Re application ref. 2023/2245/P, redevelopment and extension
of corner 'Drury Works' building at 160-161 Drury Lane, London WC2B 5PN

As the amenity society for the area, Covent Garden Community Association strongly objects to this application.

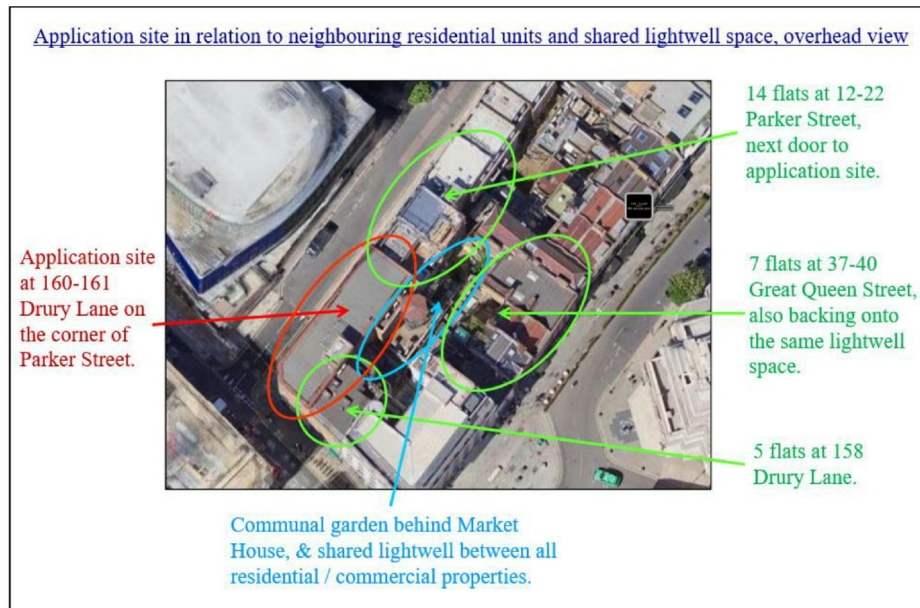
As shown in the overhead view below, a key feature of this context is that all these properties share the same lightwell space with the application building, part of which is the communal family garden for the flats at Market House. What happens in the application building has an impact upon the lives of all the people living here in terms of noise, overlooking, fumes and daylight.

Roof extension to 4th and 5th floors

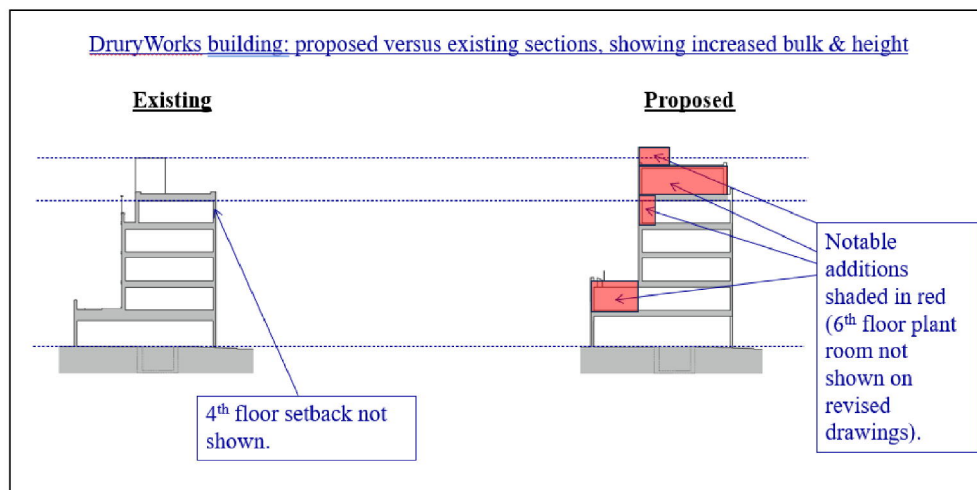
The current building is already higher than its immediate neighbours on both Drury Lane and Parker Street. Adding further height would produce a more uncomfortable relationship with those adjoining buildings.

Adding another floor would alter the building's relationship with its wider context, too, making it more incongruous and dominant in the townscape. It already forms an appropriate corner on Drury Lane and greater height would increase its prominence significantly.

The current 4th floor is approximately 1.5m lower than the (small) tallest roof on the same side of Parker Street; we imagine that the 4th floor upward extension and an additional 5th floor would render the height at least 3 metres above the tallest roof on this side of Parker Street. This is before consideration of the proposed rooftop plant, which would add even more height.

There would also be a considerable build up on the party walls, highly visible from the South on Drury Lane and the East on Parker Street.

The design of roof extension involves a revised 4th storey, extended upwards and pushed forward to the main building line, and a new 5th storey slightly set back.

Please note that the section provided on the exhibition boards (as shown in the comparative drawings above) does not show the existing setback, and we cannot see the existing 4th floor frontage setback on the application drawings; **we ask that the existing drawings be amended.**

The loss of setback on the 4th floor presents a less sympathetic addition to the streetscape, particularly on Parker Street where its width spans an extensive 10.5 bays. Together with the 5th storey, the proposed elevations to both streets and the corner result in a cliff-like prominence.

Extension of the 4th floor by almost 2m at the back, the addition on a 5th floor slightly recessed, and the addition of rooftop plant on top of that, would all have a negative impact on the residential units behind the building.

We would not object to an appropriately designed roof extension on the building, involving:

- A modest increase in the height of the current 4th floor to enable upgraded modern office use if needed, but with no increase in footplate, retaining a set-back at the front, and

- A new 5th floor designed as a sloping mansard including plant, set back considerably from the frontage to minimise visibility from the street and set back considerably at the rear to avoid amenity issues such as loss of light. Importantly, **it would also need to be set back at the sides** so as to prevent increased build up on the party walls which is detrimental to the streetscape, and to protect the amenity of the closest flat at 6 Market House whose window and terrace looks directly at this wall.
